S417 MOHICAN ROAD, BETHESDA  
MASTER PLAN SITE # 35/29-2  
R.A. CHARLES CASTLE  
And PRELIMINARY CONSULTATION

**MONTGOMERY COUNTY HISTORIC PRESERVATION COMMISSION**  
**STAFF REPORT**

<b>Address:</b>	5417 Mohican Road, Bethesda	<b>Meeting Date:</b>	7/10/13
<b>Applicant:</b>	Ross McNair	<b>Report Date:</b>	7/3/13
<b>Resource:</b>	Master Plan Site #35/29-2, R.A. Charles Castle	<b>Public Notice:</b>	6/26/13
<b>Review:</b>	Preliminary Consultation	<b>Tax Credit:</b>	Partial
<b>Case Number:</b>	N/A	<b>Staff:</b>	Josh Silver

**PROPOSAL:** Construction of rear addition, enclosure of front porch, construction of new carport and other alterations

**A.101**

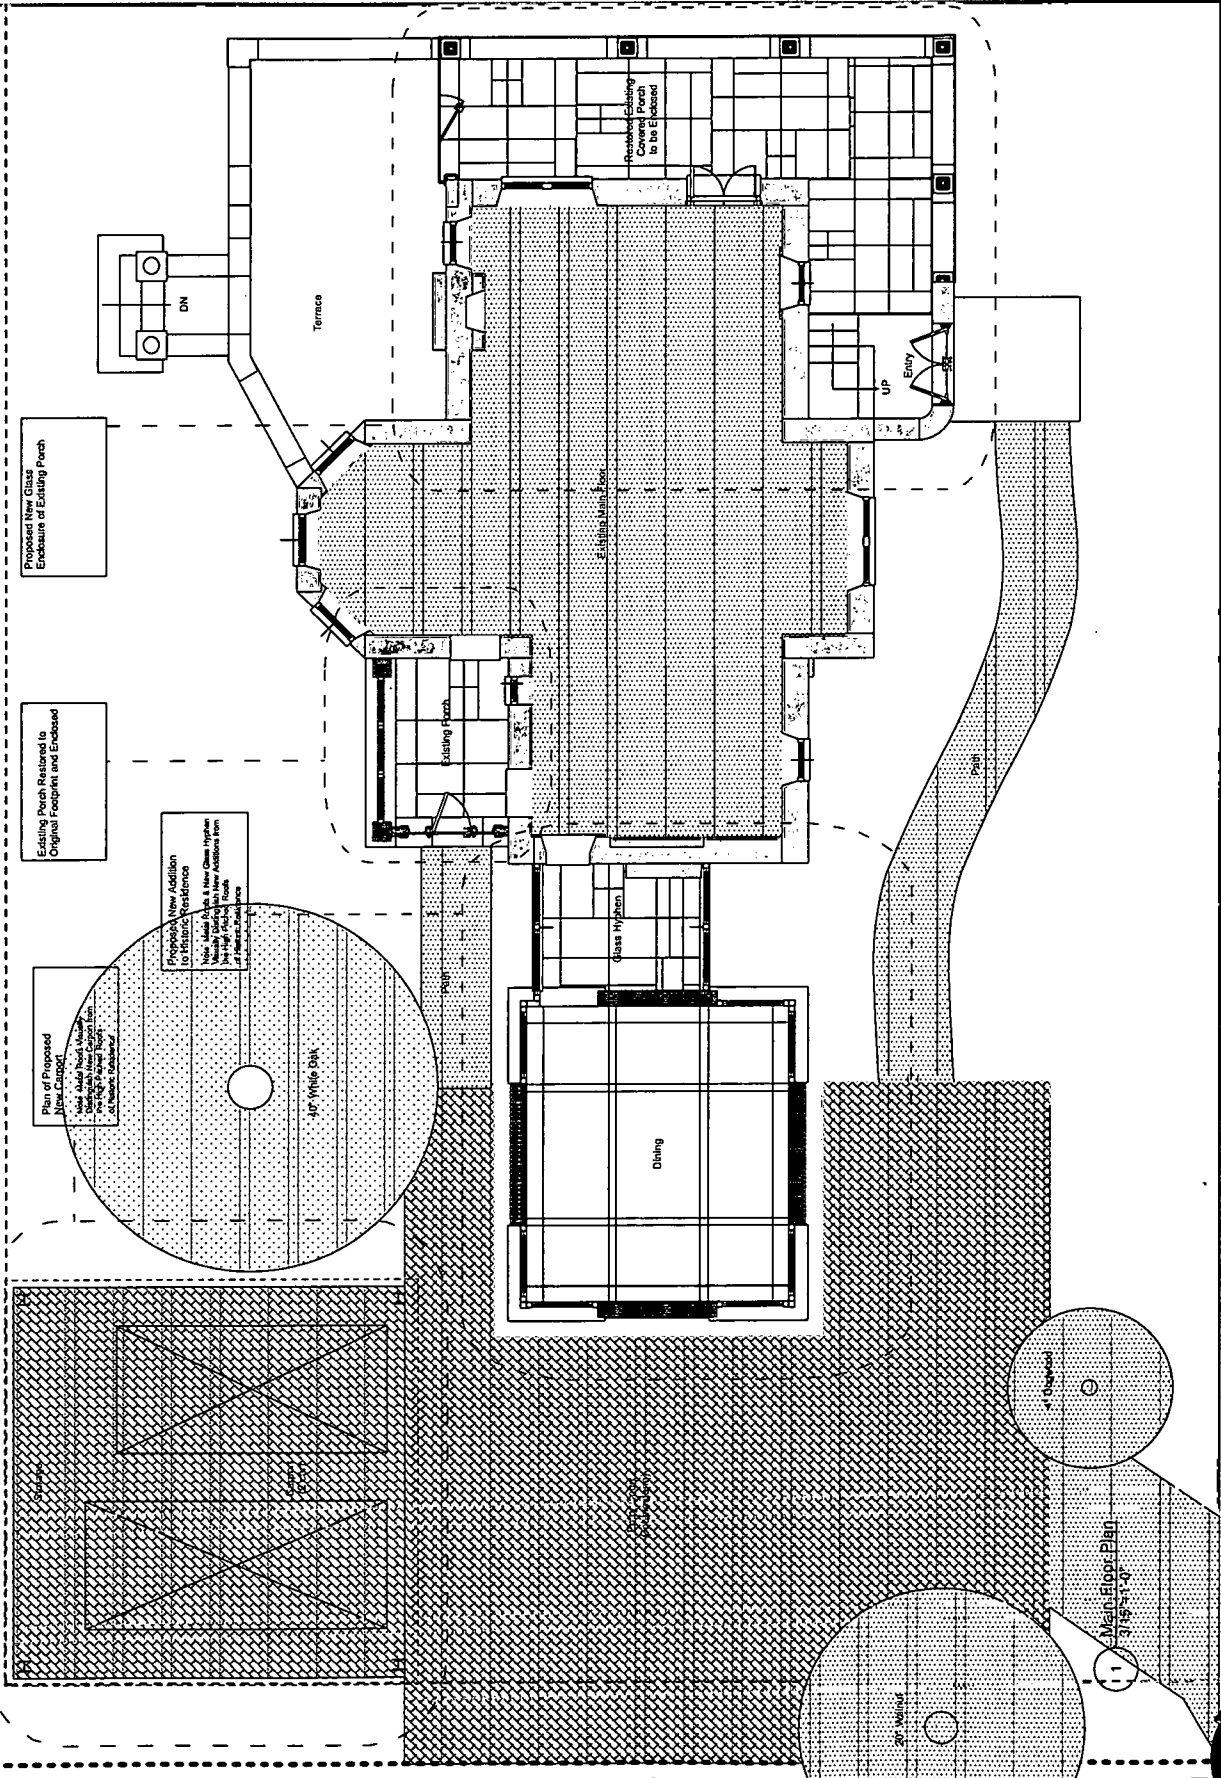
Proposed New Glass Enclosure of Existing Porch

Existing Porch Restored to Original Footprint and Enclosed

3 Porch Glazing Detail  
1/2"=1'-0"

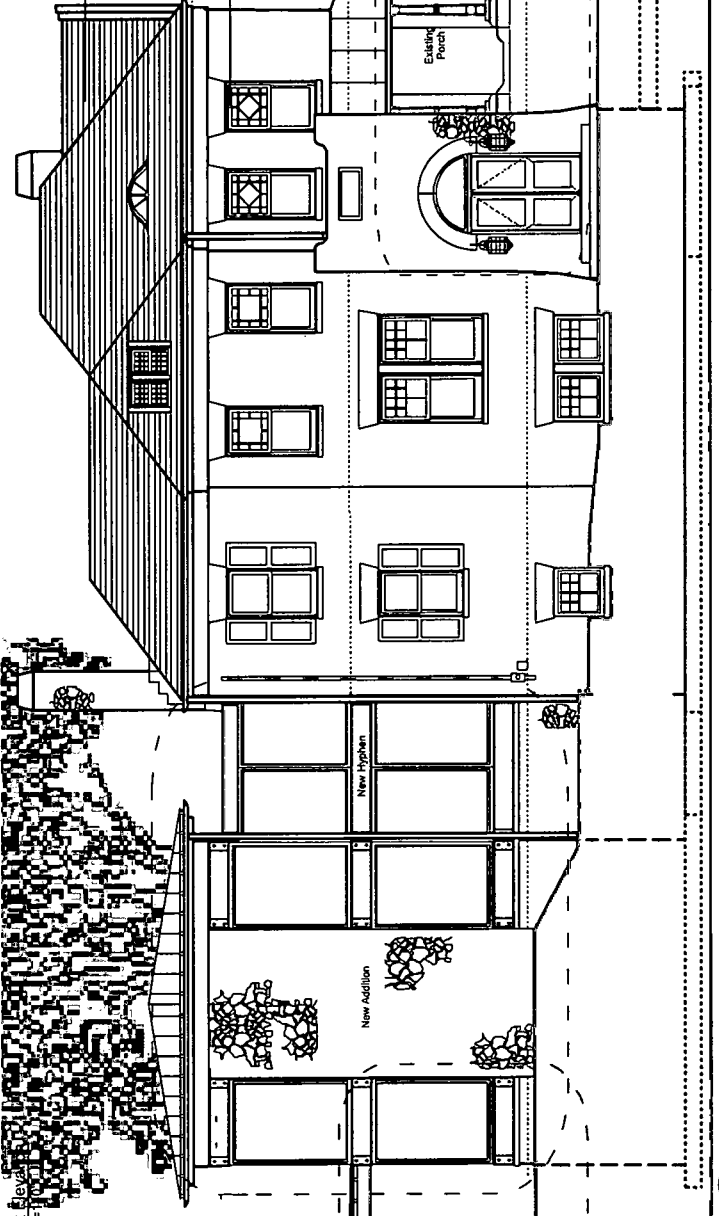
- Remove and replace a non-original asphalt roof with a seamed copper roof. Enclose the existing front porch by adding full view, fixed, reflective glass. The original wooden porch columns and stone piers will be preserved. A porch glazing detail can be found on page 23 of the staff report packet.

Staff finds enclosure of the existing front porch with fixed glass as being consistent with *Standards # 1, 9 and 10* above. The proposal requires minimal change to distinctive materials and features and does not destroy historic materials that characterize the property, and if removed in the future, the essential form and integrity of the property would be unimpaired. The proposal involves installing glass in front of the existing wooden porch columns that are original to the structure. The design preserves the porch columns and requires minimal impact to the stone piers which the column bases engage at the bottom. The porch roof form will not be impacted and the changes are reversible if removed in the future.
